# Access Compliance Report

## Public Rights-of-Way

### (Curb Ramps)

Intersection ID: N/A	Main Street: YORK_CENTER	Cross Street: N/A	Location: NW
ADA ID: B87A2EB64942	Ramp Type: PerpDiag	Initial Pass/Fail: Fail	Overall Compliance: No
		Severity Score: 30

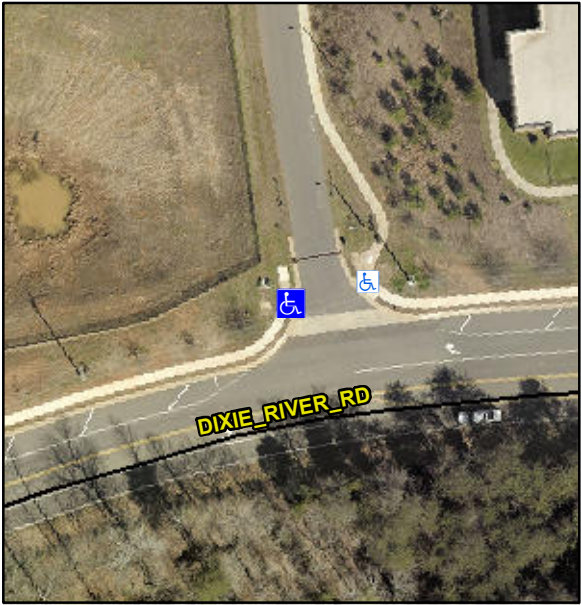
Codes/Mitigation Info/Possible Solution			Field Measurements/Component Compliance		
	Possible Solutions:		<b>Compliance</b>	<b>Description</b>	<b>Data</b>
	<b>Remove &amp; Replace Curb Ramp With Two New Directional Ramps or Equivalent.</b>		N/A	Ramp Length (in)	94.0
			No	Ramp Width (in)	35.0
			N/A	Flare Type LT	N/A
			N/A	Flare Slope LT (%)	N/A
			N/A	Flare Traversable LT?	N/A
			N/A	Landing Length (in)	N/A
			N/A	Landing Width (in)	N/A
			N/A	Landing Slope (%)	N/A
			N/A	Landing X Slope (%)	N/A
			N/A	Landing Curb? (Y/N)	N/A
			N/A	Shared Landing?	N/A
			N/A	Gutter Ponding?	N/A
			N/A	Gutter Lip Ht (in)	N/A
			N/A	Painted X Walk1?	No
				X Walk 1 Direction	To S
			N/A	X Walk 1 Width (in)	N/A
				X Walk 1 Slope (%)	4.2
				X Walk 1 X Slope (%)	3.8
			N/A	Ramp inside XWalk1?	N/A
<p>Surveyor Notes:</p> <p><b>N/A</b></p> <p>PROW/ADA:</p> <p><b>Not Found, R304.5.1, R304.5.3</b></p>			N/A	Flare Type RT	N/A
			N/A	Flare Slope RT (%)	N/A

N/A	Flare Traversable RT?	N/A
			N/A	DWS Provided?	N/A
			N/A	DWS Contrast?	N/A
			N/A	DWS Length (in)	N/A
			N/A	DWS Full Width?	N/A
			N/A	DWS Offset (in)	N/A
			N/A	Gutter Slope (%)	N/A
			N/A	Gutter X Slope (%)	N/A
			N/A	Painted X Walk2?	No
				X Walk 2 Direction	To E
			N/A	X Walk 2 Width (in)	N/A
				X Walk 2 Slope (%)	4.0
				X Walk 2 X Slope (%)	4.8
			N/A	Ramp inside XWalk2?	N/A
			N/A	Clear Space?	N/A
			N/A	Clear Space to XWalk (in)	N/A
			N/A	Storm Grate/Utility Hazard?	N/A
				Storm Grate/Utility Type	
			N/A		N/A
			Yes	Surface Condition? (G/P)	Good
Total Cost:		\$ 3200.00
